Effect of SA09 40 dB (A) limit vs SA03 35dB(A) limit on Compliance at Dixon Property M Morris 2015

Figure 3: Post-construction noise levels vs. wind speed at the Dixon property

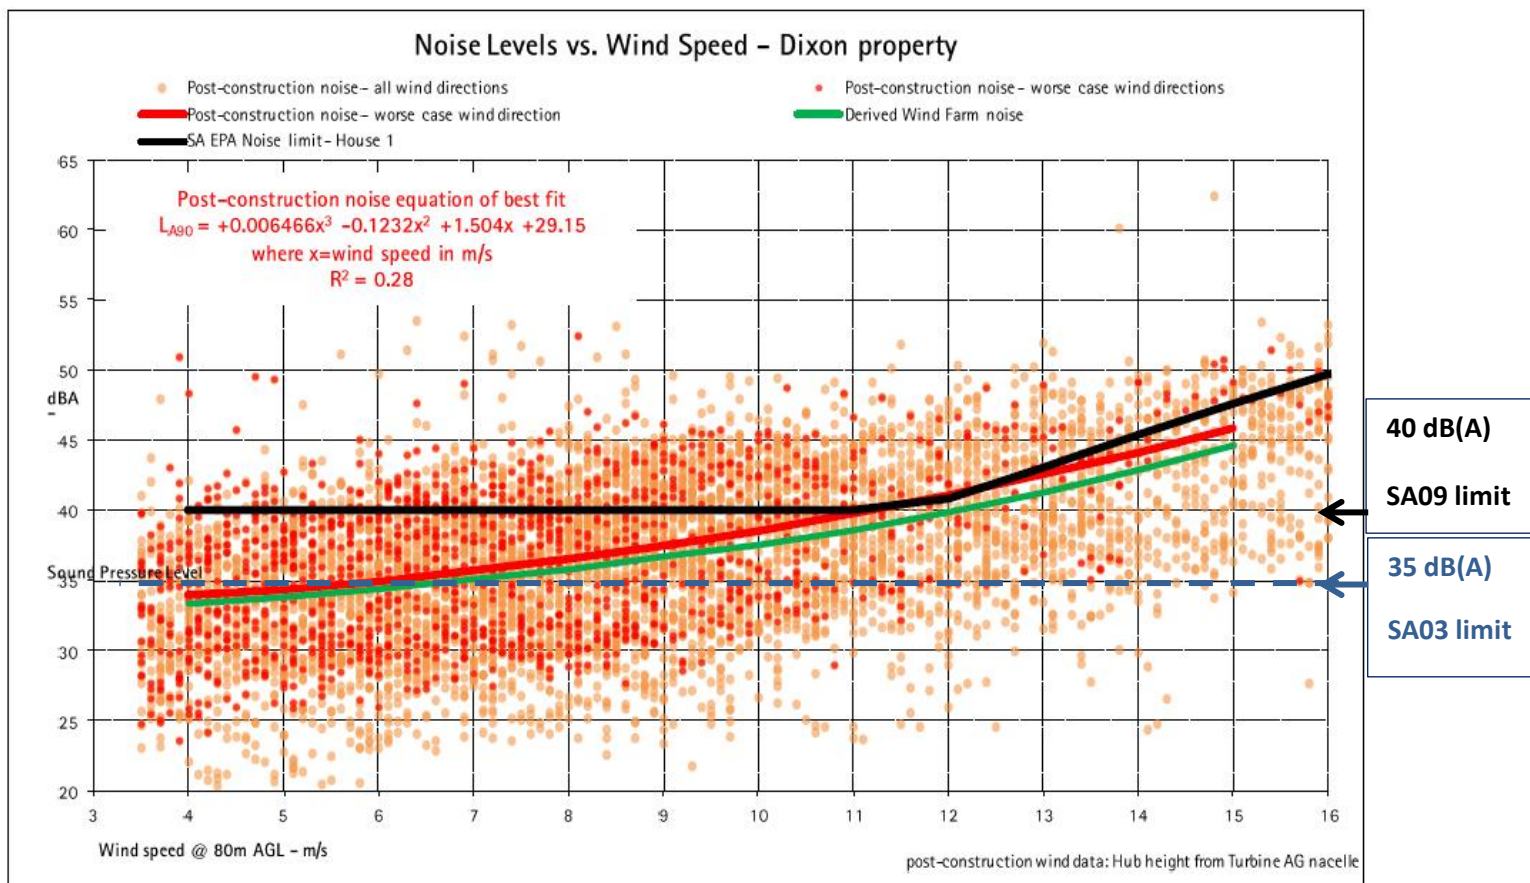
Conclusion:

Using the SA03 35 dB (A) limit would mean that at wind speeds over 7 m/s, the Waterloo wind farm would not be compliant.
